COLORADO
Division of Water Resources
Department of Natural Resources

June 26, 2019

Re: Bennett Pit Substitute Water Supply Plan (WDID 0202664)
DRMS File No. M-2016-085(WDID 0210524)
Sections 1 and 12, T2N, R67W of the 6th P.M.
Water Division 1, Water District 2, Weld County
SWSP ID: 6078

Approval Period: June 26, 2019 through February 28, 2021 (or May 31, 2021 subject to condition of approval no. 1)

Figure 1

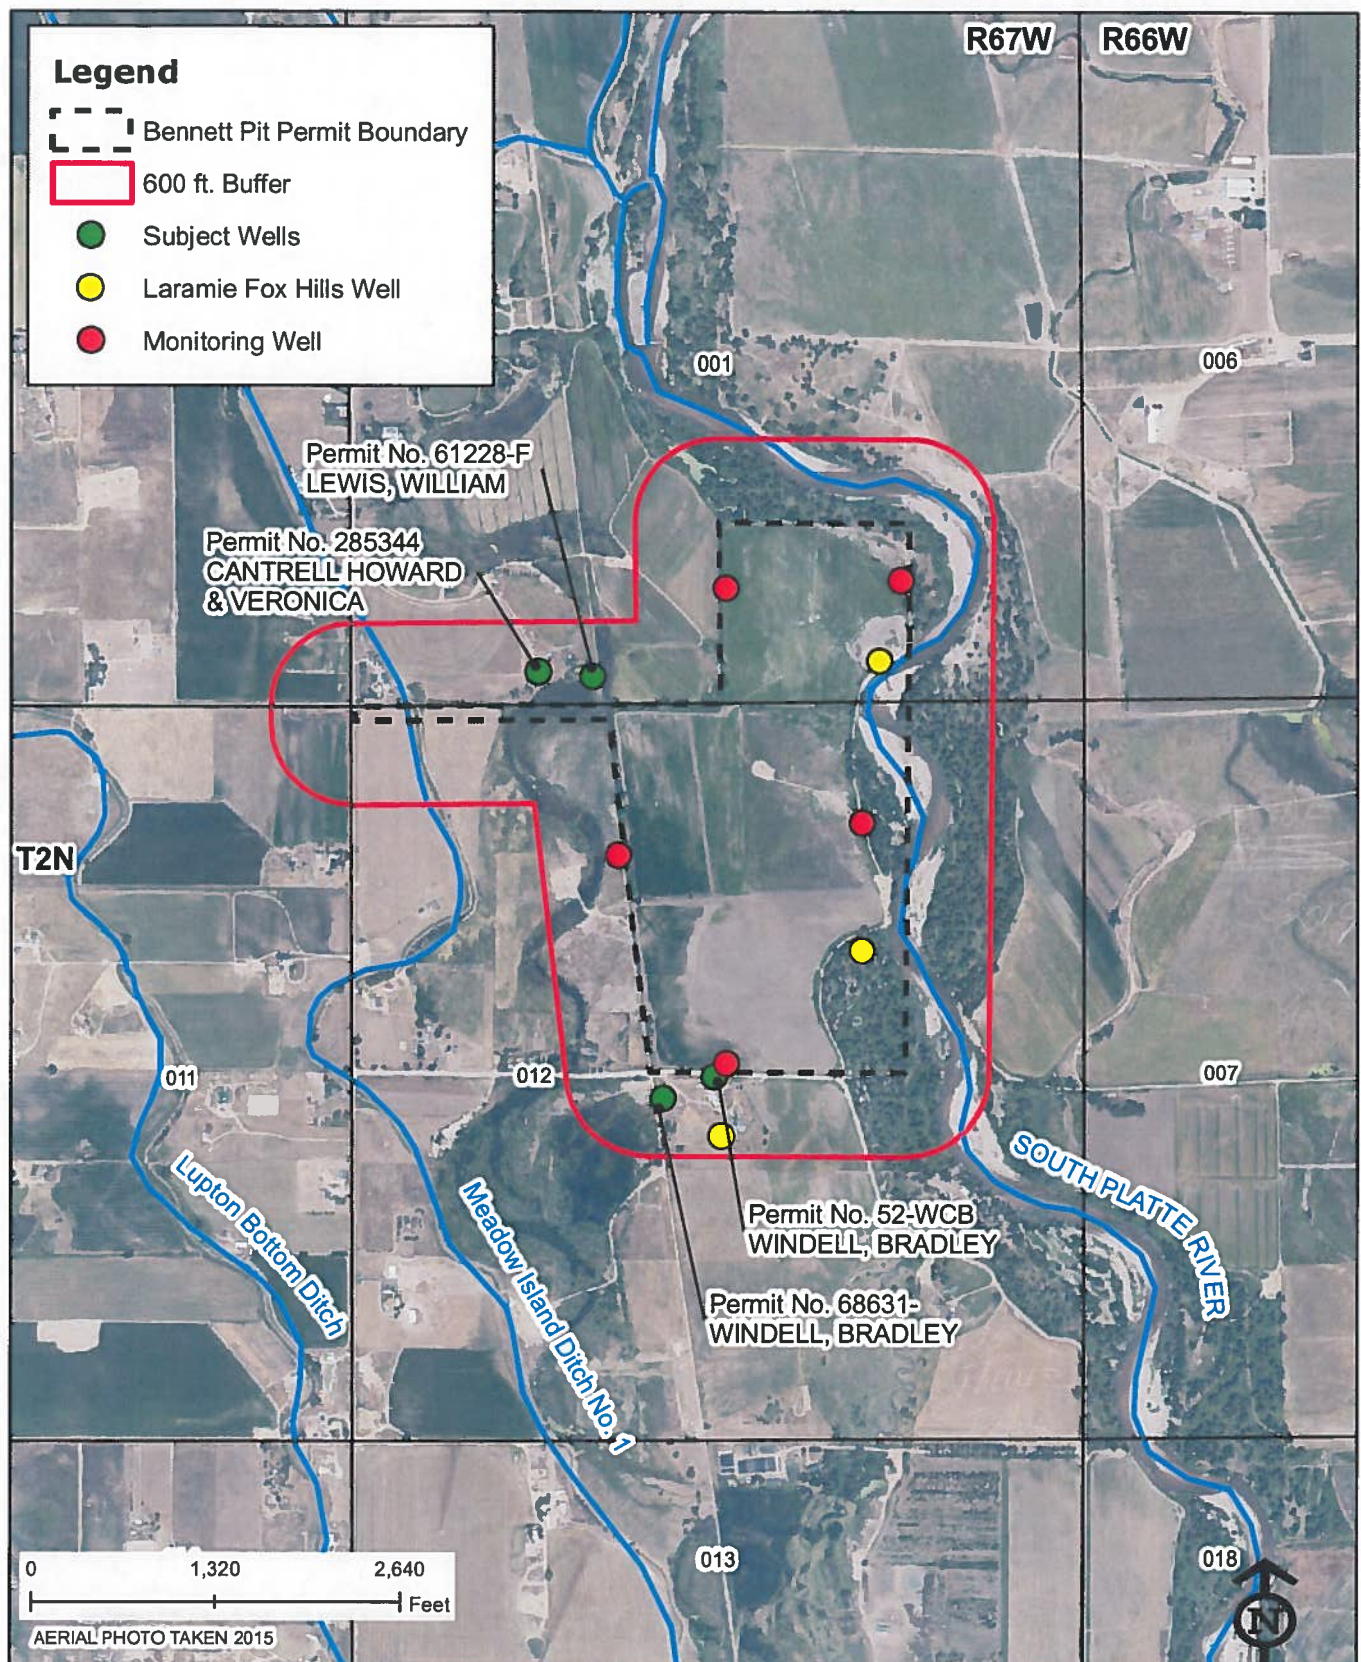
The Bennett Pit is located in the SW1/4 of the SE1/4 of Section 1, and the N1/2 of Section 12, all Township 2 North, Range 67 West of the 6th P.M. (Figure 1). This SWSP seeks to replace depletions resulting from the mining operation over the first two years of operation include evaporation from exposed ground water, dust suppression, dewatering, and water lost with the mined product. In addition, NCCI will be installing a slurry wall concurrent with mining. The life expectancy of the Bennett Pit is approximately 10-15 years. Approximately 300,000 tons are to be excavated from the pit each year. The proposed reclamation of the site is a lined reservoir through the construction of a slurry wall around the mining area. The proposed replacement of depletions for this site during the period of this SWSP will come from dewatering accretion credits associated with the dewatering at the site.

3. The surface area of the groundwater exposed at the Bennett Pit site must not exceed 11 acres during this plan period, which results in a maximum evaporative annual loss of 29.3 acre-feet.
